# MANDATORY SERVICE BULLETIN

DATE: February 3, 2016 Service Bulletin No. 623  
Engineering Aspects are  
FAA Approved

SUBJECT: Reprint of Hartzell Engine Technologies (HET) Service Bulletin SB-062

### Alternator Models ALU, ALX & ALY Series HET P/N ALA-0020G Through Bolt Replacement

Figure 1 - ALX-8521LS Pan-Head Through Bolt Head Separation Example Shown with Fan Removed.

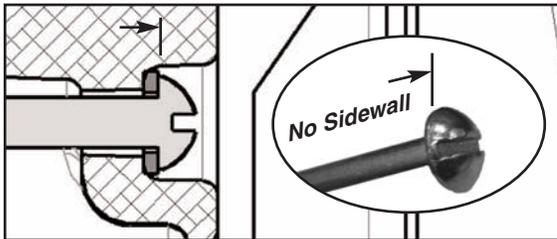
- (1) Affected serial numbers of alternator model ALU, ALX, and ALY may have a pan-head style HET P/N ALA-0020G through bolt installed. These pan-head through bolts have had incidences of bolt head separation. Refer to Figure 1.
- (2) To eliminate the risk of through bolt head separation, all pan-head through bolts must be replaced with HET P/N ALA-0020G fillister-head style through bolts on the affected alternators. Refer to Figure 2 and Figure 3.
- (3) The pan-head version of the HET P/N ALA-0020G through bolt is being discontinued and will no longer be used.
- (4) Regulatory action is unknown.

- (1) This Service Bulletin provides Instructions for Continued Airworthiness (ICA).
- (2) This Service Bulletin requires an inspection of the affected alternators shown in Tables 1, 2, or 3 and return of any that are found with pan-head through bolts installed.
  - a. The alternator will be repaired using HET P/N ALA-0020G fillister-head through bolts.

Figure 2 - Pan-Head Through Bolt (If found alternator must be repaired)

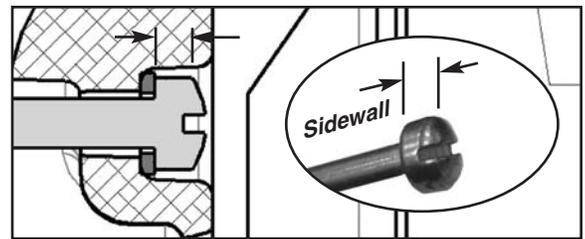
- (1) Using a bright white light, inspect the alternator drive end housing at each through bolt location (four each) beneath the fan. Refer to Figure 4.
  - a. If a pan-head through bolt is installed, return the affected alternator to HET for repair per 3.C Corrective Action. Refer to Figure 2.
  - b. If positive identification that four fillister-head through bolts are installed, the affected alternator is in compliance with this service bulletin. Proceed to 3.D(3), Return to Service. Refer to Figure 3.

- a. Remove the affected alternator from the engine in accordance with the applicable aircraft and/or engine maintenance manual or service instruction.
- b. Return all affected alternators directly to HET for repair per section 4 Contact Information.
  - (i). Include the completed SB 062 Claim form found in the Commercial Appendix attached to this Service Bulletin along with the HET supplied RMA number.
